CITY OF ALBUQUERQUE

**RE: Allaso Vineyards Apartments
Conceptual Drainage Report
Engineer's Stamp Date: No Engineer's Stamp Date
Hydrology File: C20D086**

Based upon the information provided in your submittal received 12/16/2020, the Conceptual Drainage Report is approved for action by the DRB on Site Plan for Building Permit.

Sheet C-101

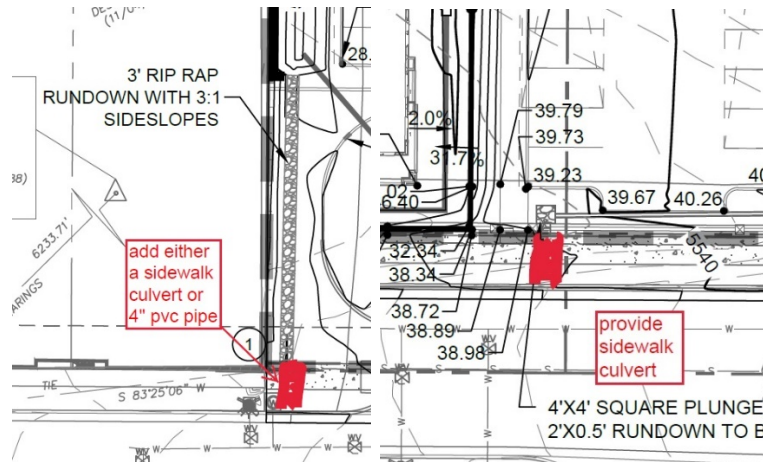
1. Stormwater discharges across the sidewalk are not allowed on collector roads and above; provide sidewalk culverts or drain lines through the curb. (See below)

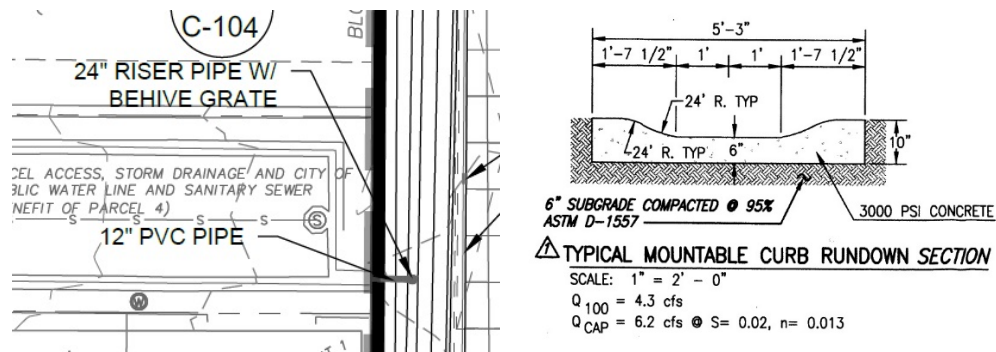
- Please show in more detail as how the proposed 12" PVC will be outfall into the existing mountable curb runoff (see below). A section showing the riser pipe with all needed elevations may be of some help.

PROJECT NAME:		ALLASO VINEYARDS		APARTMENTS HOLLY &		VENTURA			
SHEET TITLE:		SECTIONS							
SUBMITTED FOR:									
SHEET NUMBER:		C-104

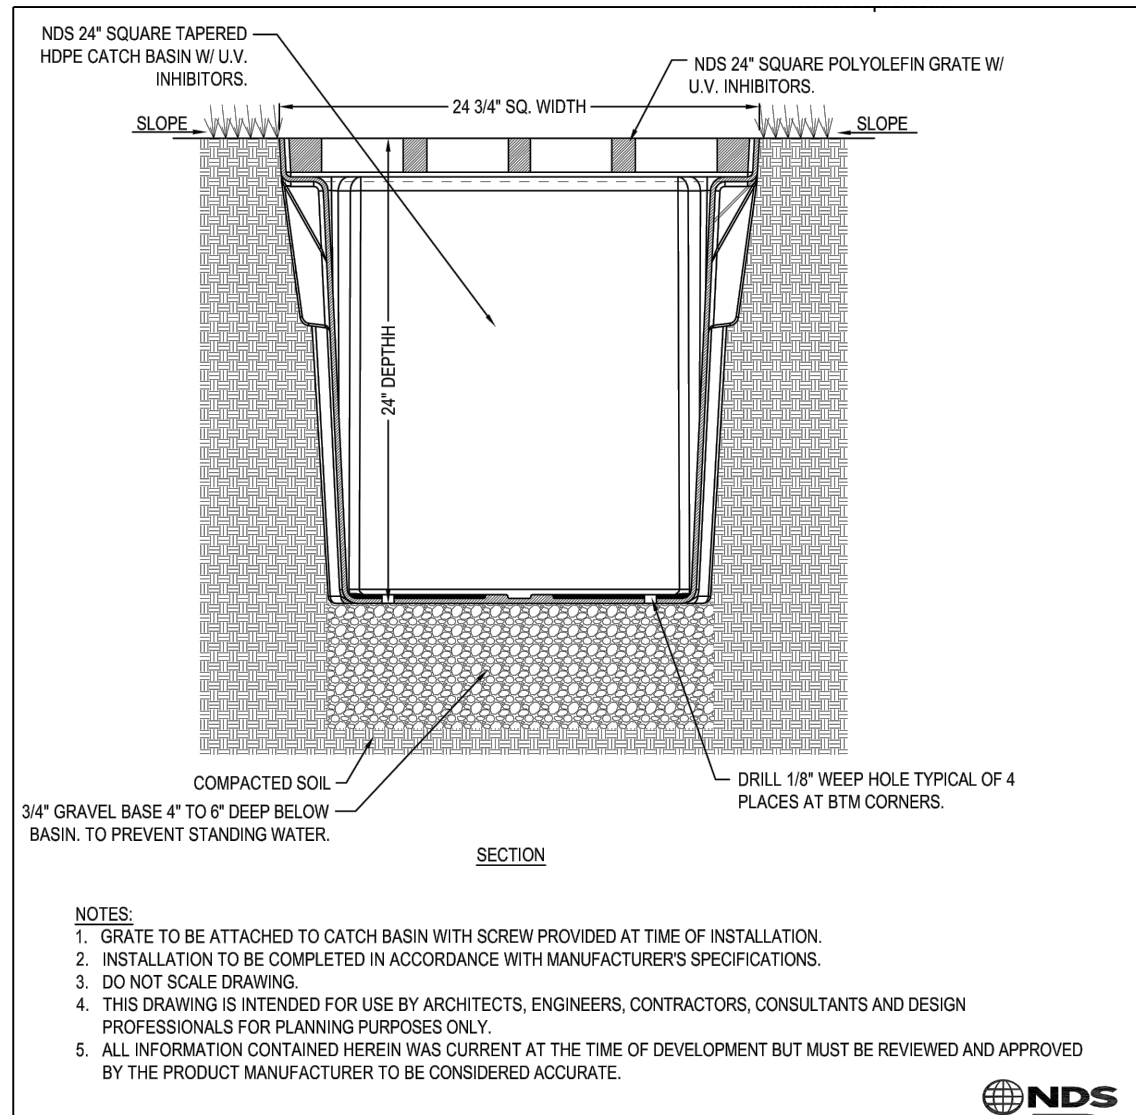
1. Section 2. A waterblock, 0.87' high, per COA Paving Detail No. 2426, is required at the driveway entrance. It appears that this needs to be provided.
2. Section 8. A waterblock, 0.87' high, per COA Paving Detail No. 2426, is required at the driveway entrance. It appears that this needs to be provided.
3. Section 9. Please add a note stating that the contractor shall waterproof the existing retaining wall below the 100-yr 24-hour water surface elevation of 26.0 per City standards.

C-105

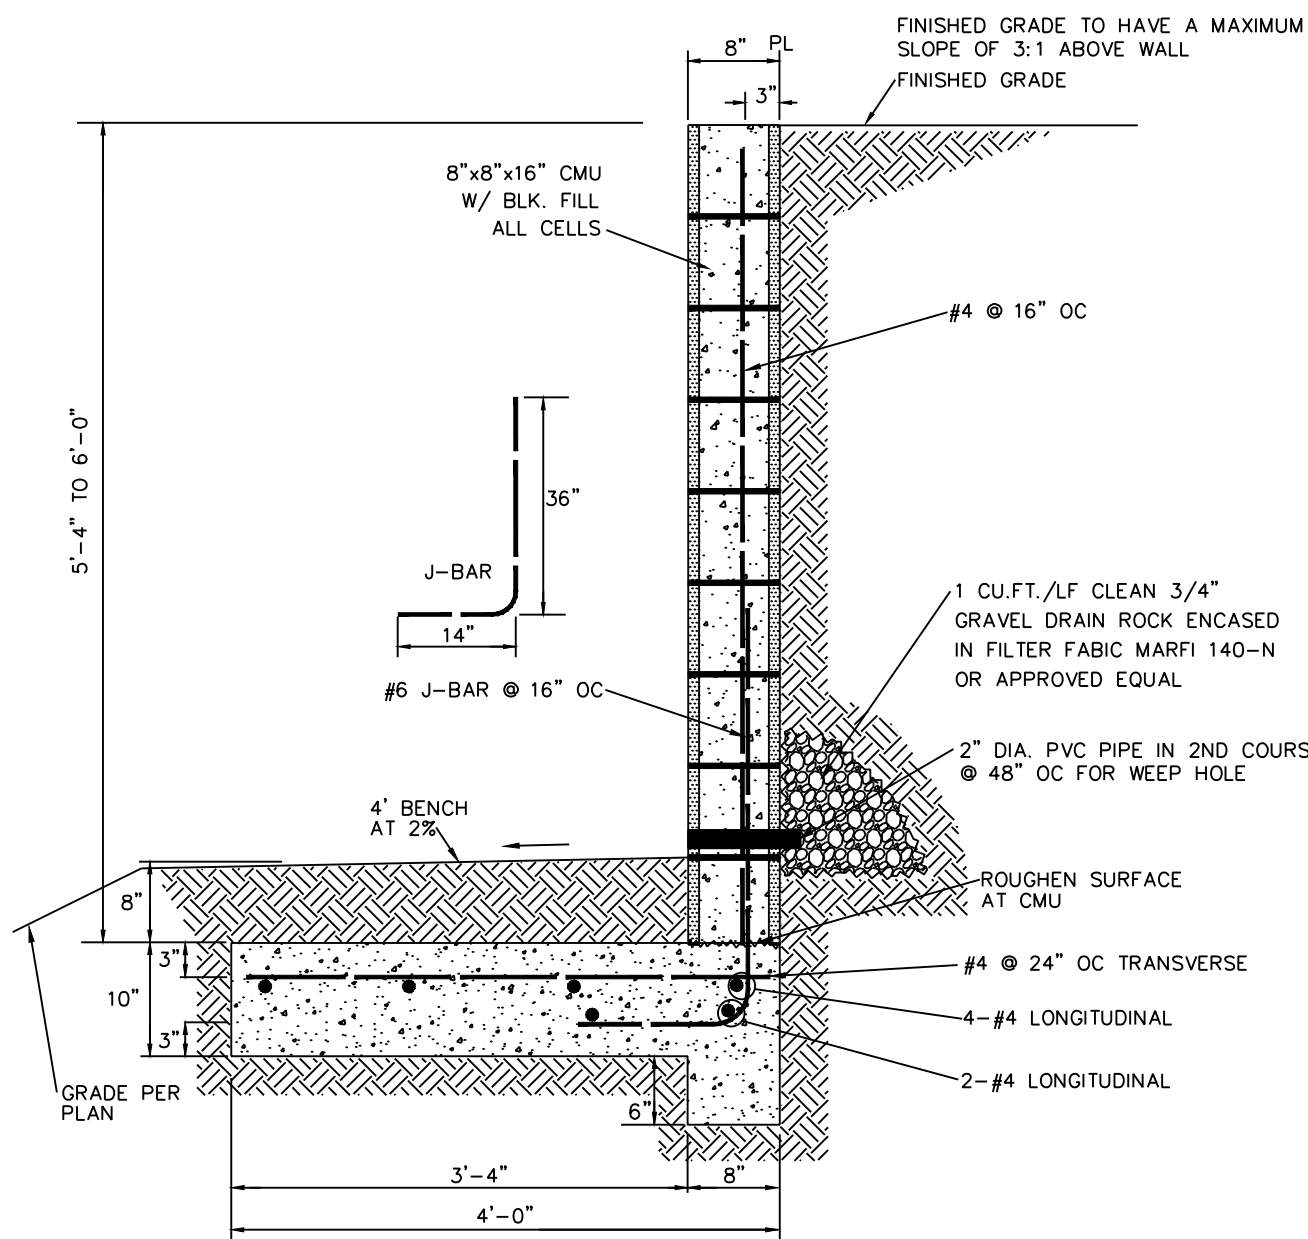
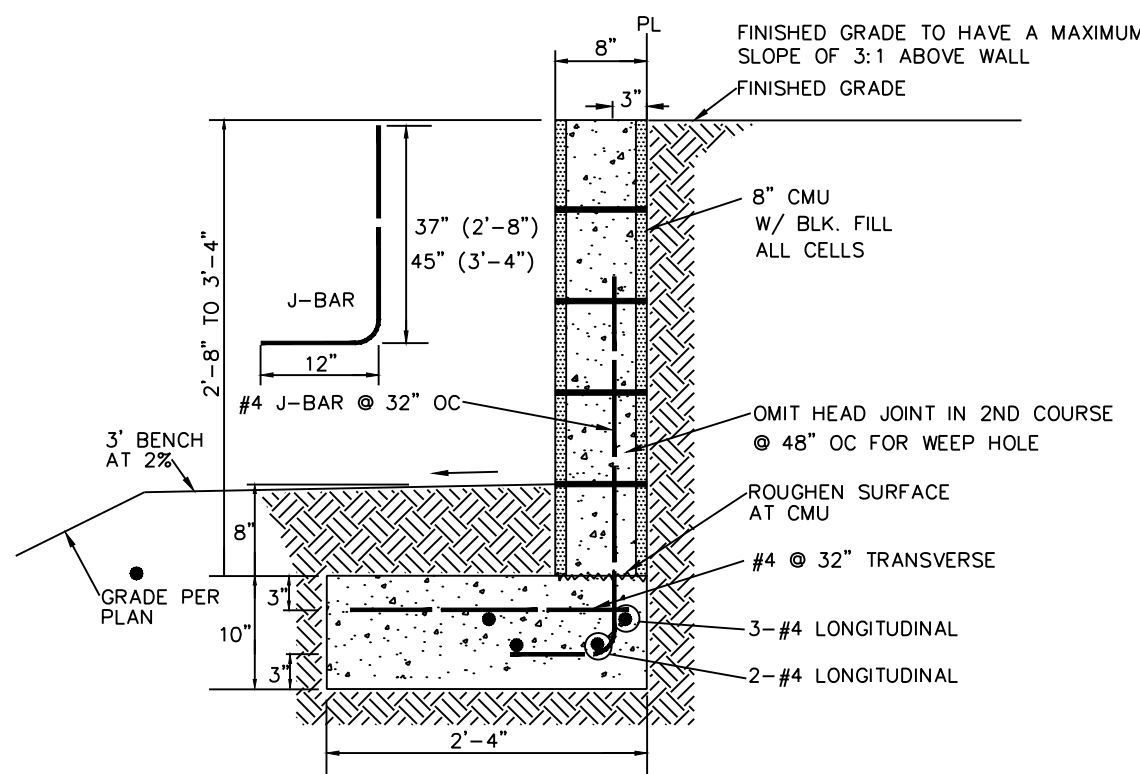
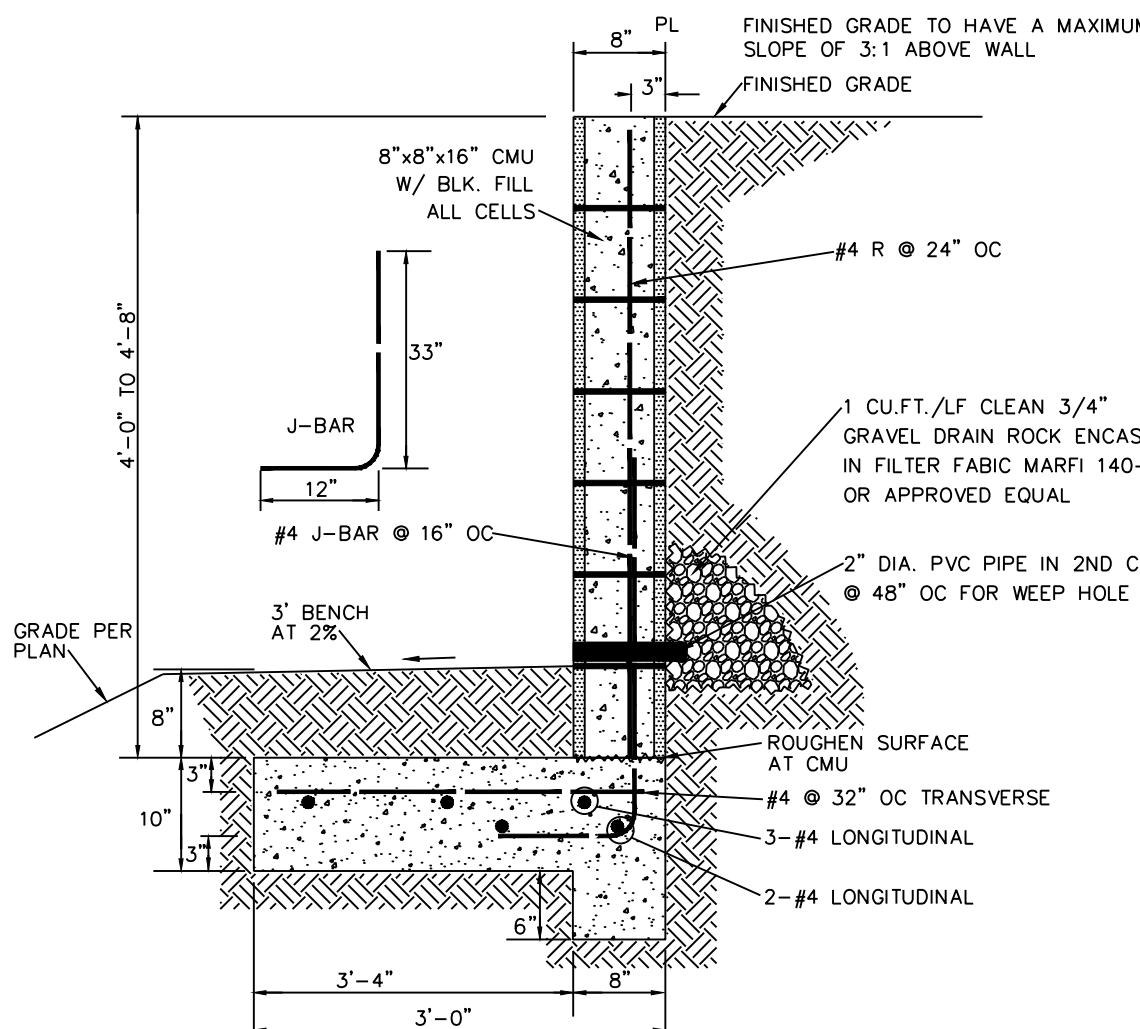
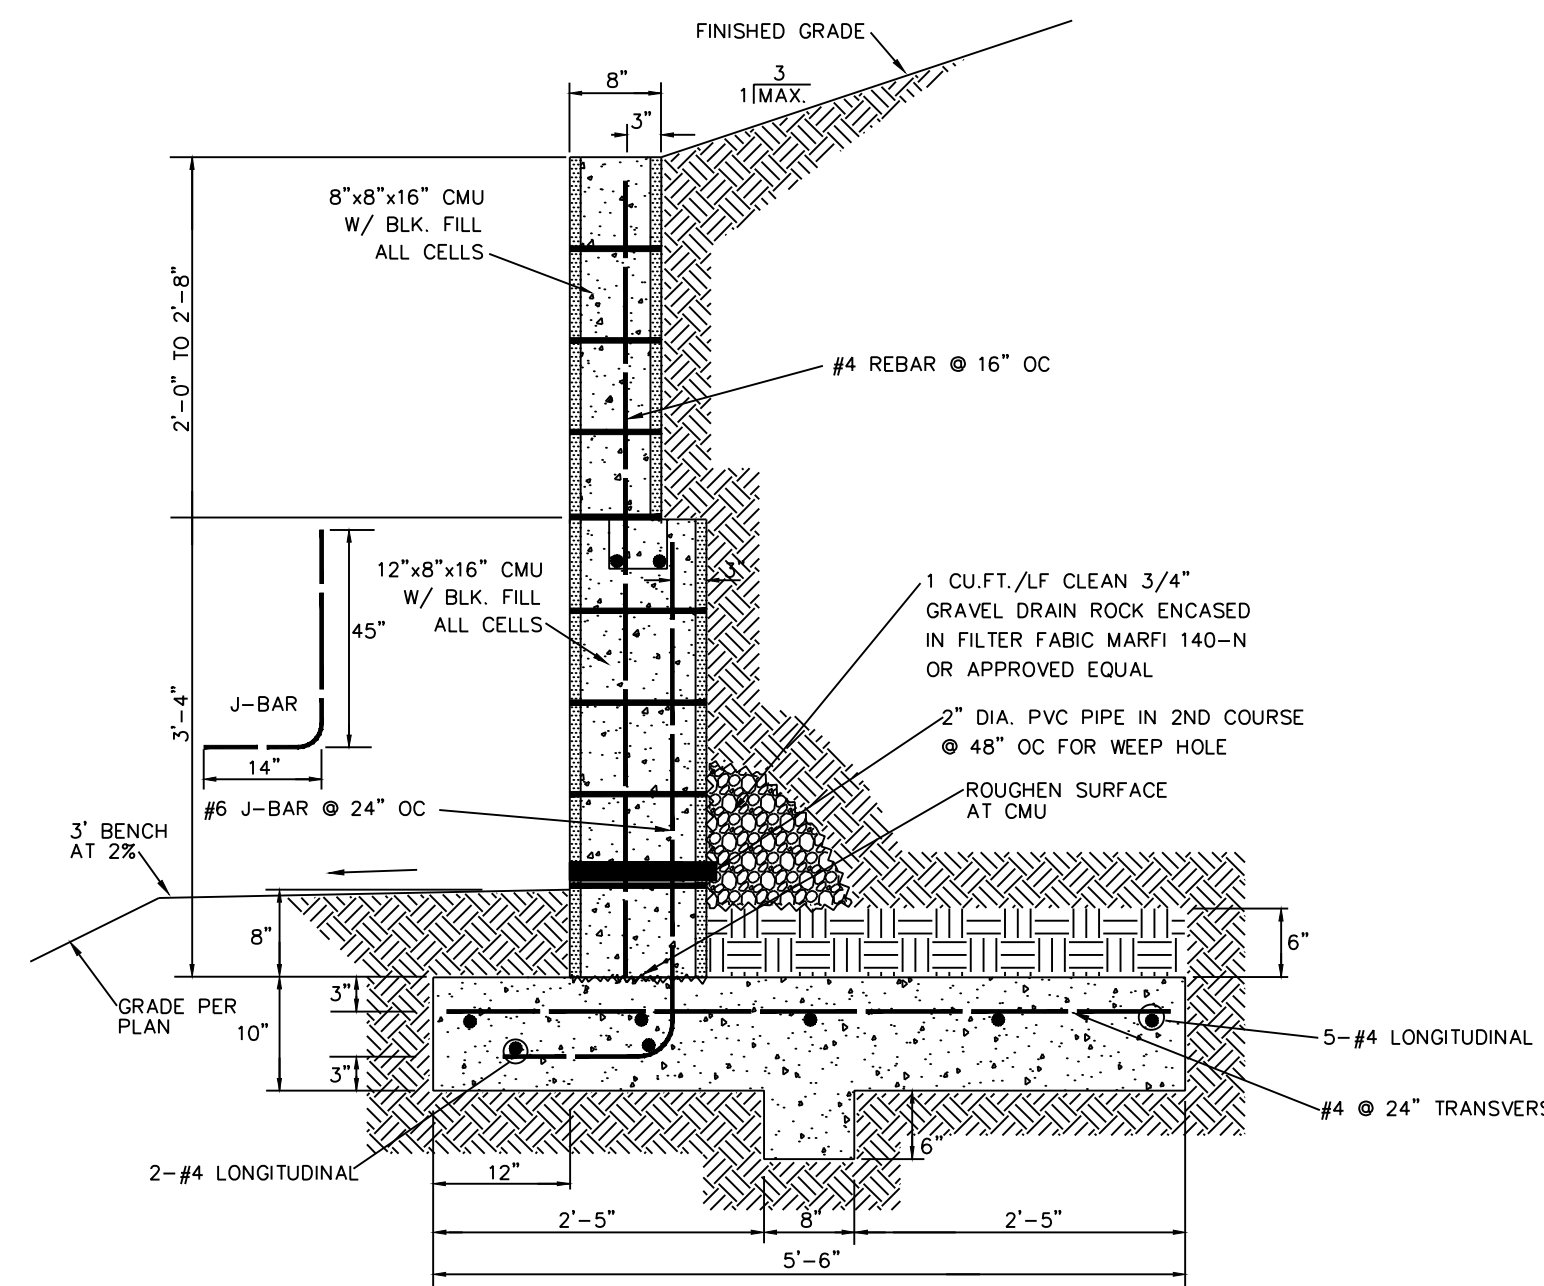
1. Please provide all structural calculations that corresponds with the retaining details to ensure that they will work especially the ones right next to the R.O.W. These calculations can be submitted as a separate document with an engineering stamp and signature & date with the submittal.
